## Exhibit 6.2

Enfield Pointe Matrix of Required Retrofits to Public and Common Use Areas

## ENFIELD POINTE APARTMENTS: PUBLIC AND COMMON USE AREAS

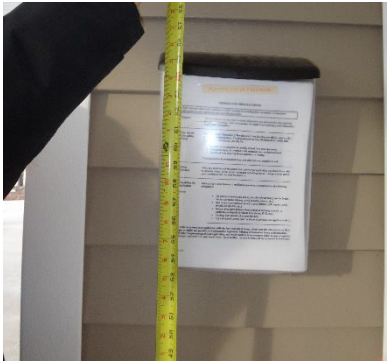
Numbers	Inaccessible Brochure Holder	Deficiency	Required Retrofit
1	 <p><i>Brochure holder.</i></p>	The brochure holder is 55-1/2 inches above the floor (maximum 54 inches allowed).	Relocate brochure holder to comply with ANSI 4.2.6.
<b>Inaccessible Restroom Features</b>			
2	 <p><i>Height of coat hook in women's restroom.</i></p>	The women's restroom coat hook is more than 56-1/2 inches above the floor (maximum 54 inches allowed).	Modify coat hook to comply with ANSI 4.2.6.
